**Associated
Engineering**

June 12, 2009

**Re: REVIEW OF THE DEVELOPMENT AND IMPLEMENTATION OF THE
NEW DESIGN VEHICLES FOR THE DESIGN OF BRIDGES - REVISION 1**

Figure 1
Light Off-Highway Design Vehicle
GVW: 72,375 kg

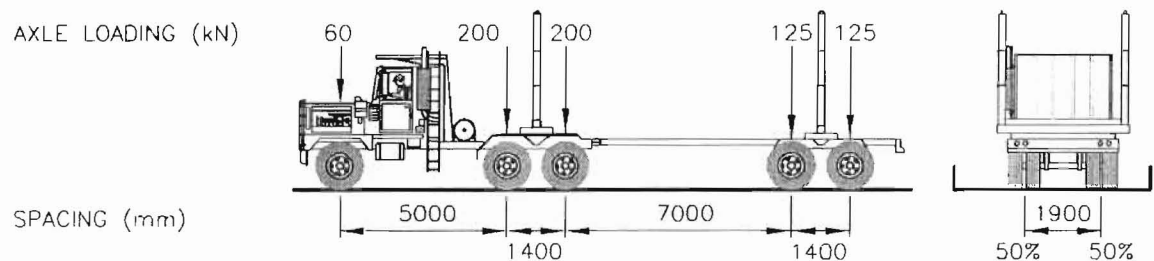
The proposed design vehicles are calibrated for use with the Live Load factors and Dynamic Load Allowance specified in CSA S6-06 and are intended for use when designing girders and stringers. Although the proposed design vehicles were developed for the design of longitudinal girders, preliminary review suggests that they can be used for deck design. Figures 1 and 2 illustrate the two proposed off-highway design vehicles.
